Administrative Approval Action

SR-87-18 / Noir Bar & Lounge Addition
Transaction# 568906 AA#3982

Design Adjustment Staff Response

PROJECT	Project Name	Noir Bar & Lounge	
	Development Case Number	A SR-87-2018	
	Transaction Number	568906	
	Design Adjustment Number	DA - 4 - 2019	
STAFF RESPONSE	Staff recommendation based upon the findings in the applicable code(s):		
	<input type="checkbox"/> UDO Art. 8.3 Blocks, Lots, Access	<input checked="" type="checkbox"/> UDO Art. 8.5 Existing Streets	
	<input type="checkbox"/> UDO Art. 8.4 New Streets	<input type="checkbox"/> Raleigh Street Design Manual	
	Staff SUPPORTS <input type="checkbox"/> DOES NOT SUPPORT <input type="checkbox"/> the design adjustment request.		
	DEPARTMENTS		
	<input type="checkbox"/> Dev. Services Planner	<input type="checkbox"/> City Planning	
	<input checked="" type="checkbox"/> Development Engineering	<input type="checkbox"/> Transportation	
	<input type="checkbox"/> Engineering Services	<input checked="" type="checkbox"/> Parks & Recreation and Cult. Res.	
	<input type="checkbox"/> Public Utilities

PROPOSED SITE PLAN

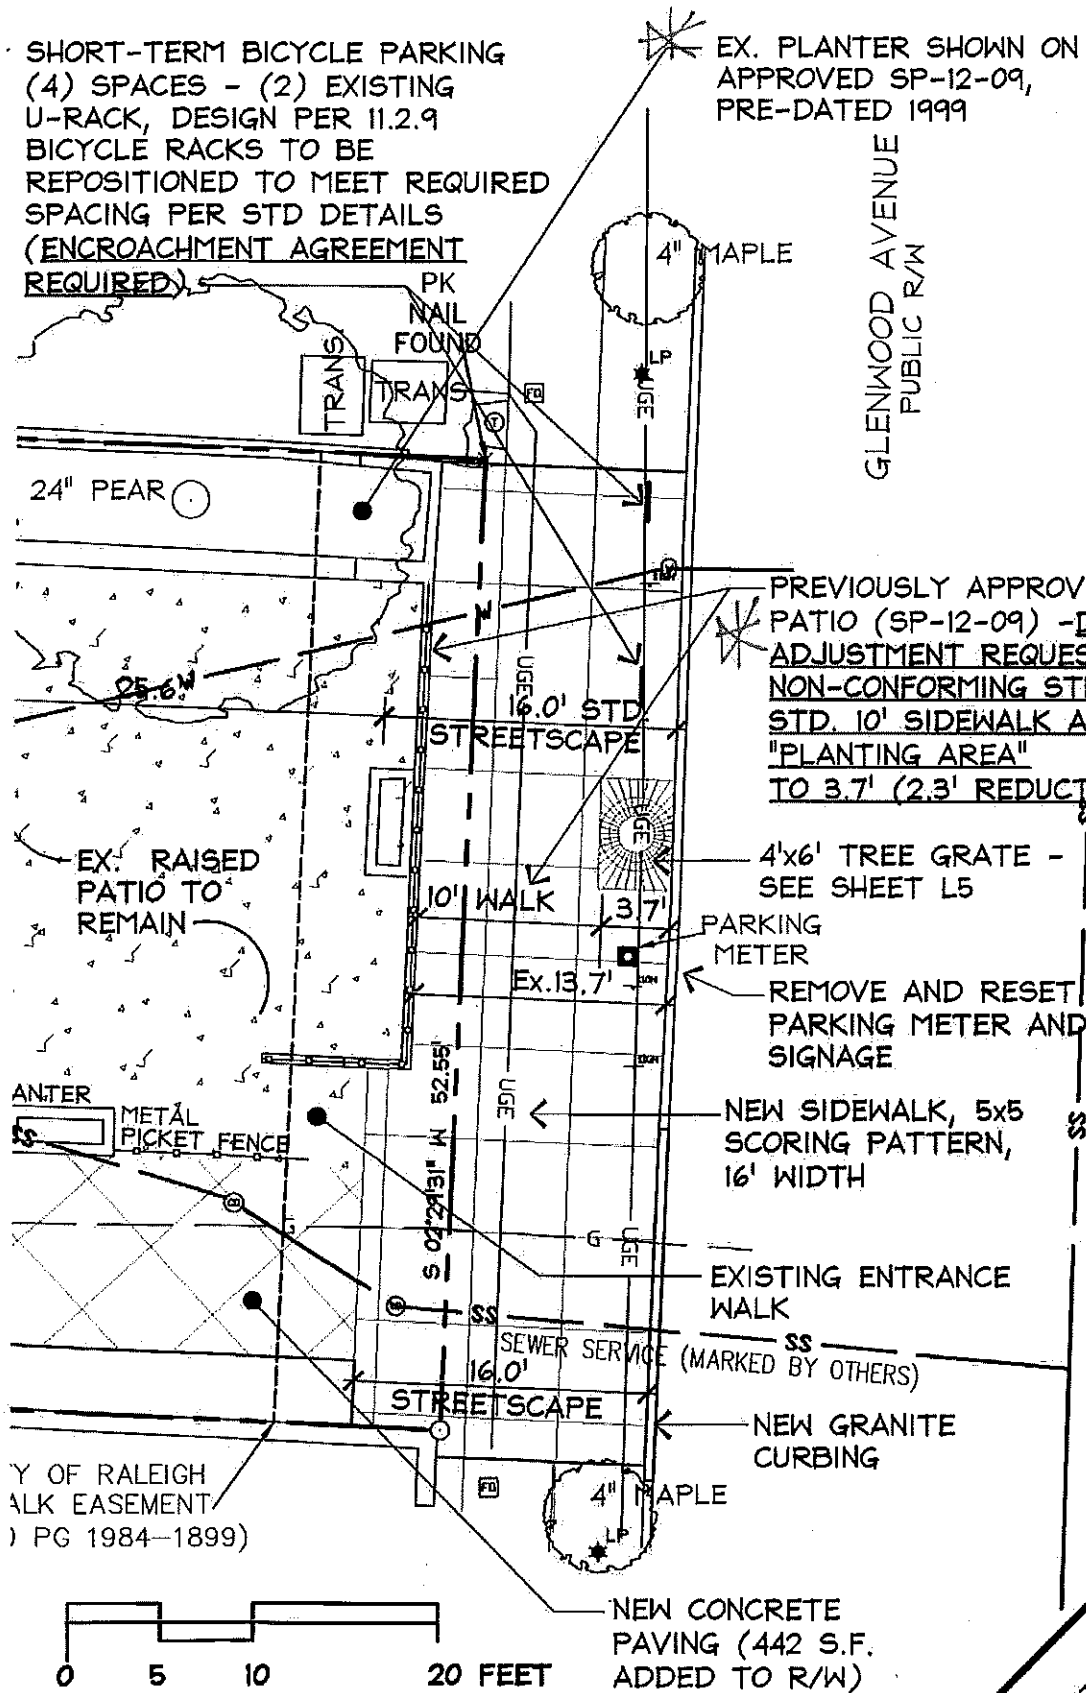
Glenwood Avenue is designated as a Main Street Parallel Parking. The required right-of-way width is 90 feet. This requires dedication of 1/2 - 90' right-of-way along the frontage of 510 Glenwood Avenue.(RSDM 3.2.4 A, UDO 8.5.1 B.1.a).

The client is also requesting a design adjustment to the standard streetscape width. The approval of SP-12-2009 allowed for a raised patio to be constructed on the property, but now encompasses part of the required Main Street Streetscape width of 16 feet on the property.

The planting area width is reduced from 6 feet to 3.7 feet. The development will still provide the required planting area for the tree with a tree grate and 600 cubic feet of structural soil in accordance with the City of Raleigh tree planting detail TPP-006 and TPP-007.

The sidewalk width is ten feet measured to the raised platform and ADA accessible. The area of the sidewalk on the property is within an existing sidewalk easement Book 14210 Page 01894.

PREVIOUSLY APPROVED RAISED
PATIO (SP-12-09) - DESIGN
ADJUSTMENT REQUEST FOR
NON-CONFORMING STREETScape WITH
STD. 10' SIDEWALK AND REDUCED
"PLANTING AREA"
TO 3.7' (2.3' REDUCTION)
